Document Title: Generic Environmental Impact Statement for License Renewal of Nuclear Plants, Supplement 22, Regarding Millstone Power Station, Units 2 and 3

Re: **Draft Report For Comment on Generic Environmental Impact Statement for License Renewal of Nuclear Plants, Regarding Millstone Power Station, Units 2 and 3, NUREG-1437, Volumes 1 and 2, Supplement 22**

Re: Draft Supplemental Environmental Impact Statement (DSEIS) for License Renewal of  
Nuclear Plants at the Millstone Power Station, Units 2 and 3, NUREG-1437, Supplement 22  
(EPA ERP #NRC-B06005-CT)

Figure 6-1  
Strontium-90 in Milk

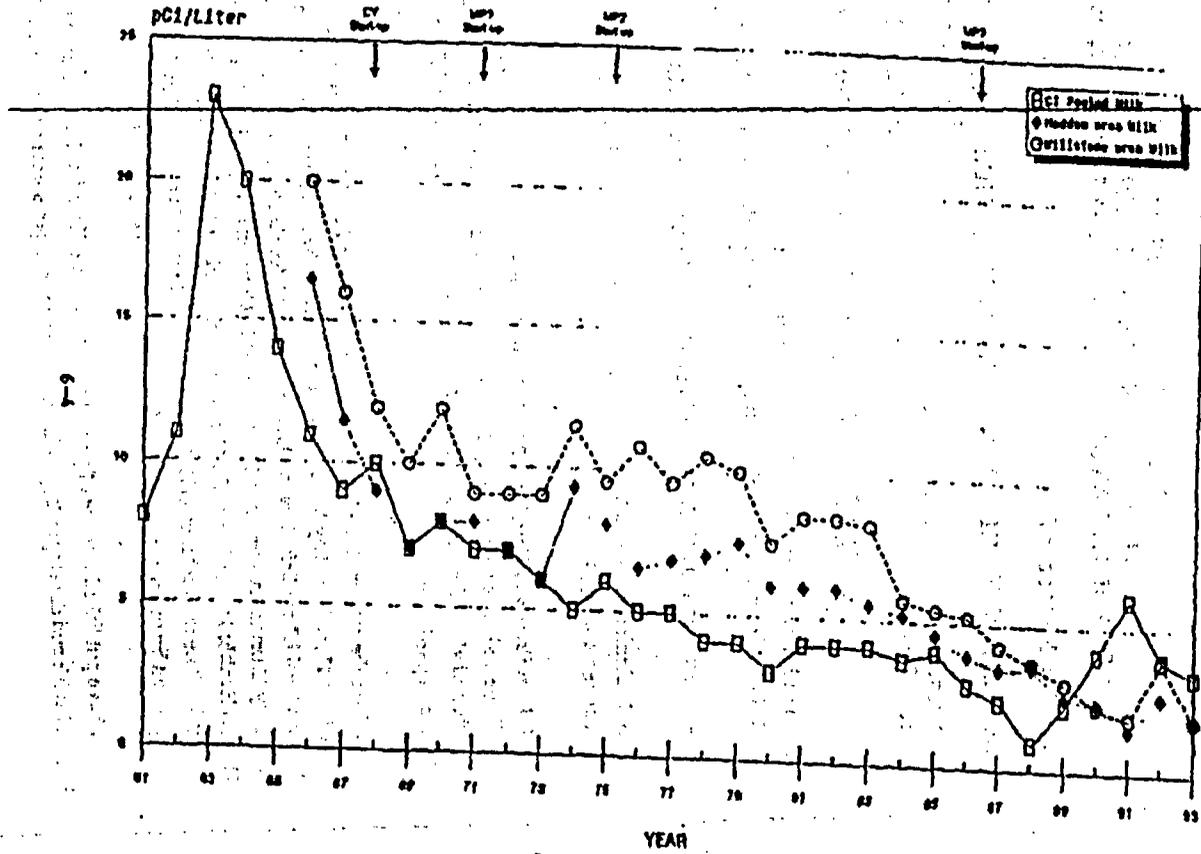
Thus, in the enclosed copy of Table 8 of the Report for the year 2001, a concentration of 55.5 picoCuries per liter (PCI/L) of milk of Strontium-90 was reported for Location 22 for the sample measured on September 19, 2001, with an uncertainty of plus or minus 5.3 PCI/L. This is an extremely large concentration, close to twice the highest concentration measured in Connecticut pooled milk at the height of nuclear weapons testing in 1963 of 23 PCI/L, as can be seen from the enclosed Figure 6-1 prepared by the Dominion Company for the period 1961 to 1993. Moreover, since the measured value is ten times as large as the measurement uncertainty, this is an extremely significant result, with an astronomically small chance that it is a statistical fluctuation.
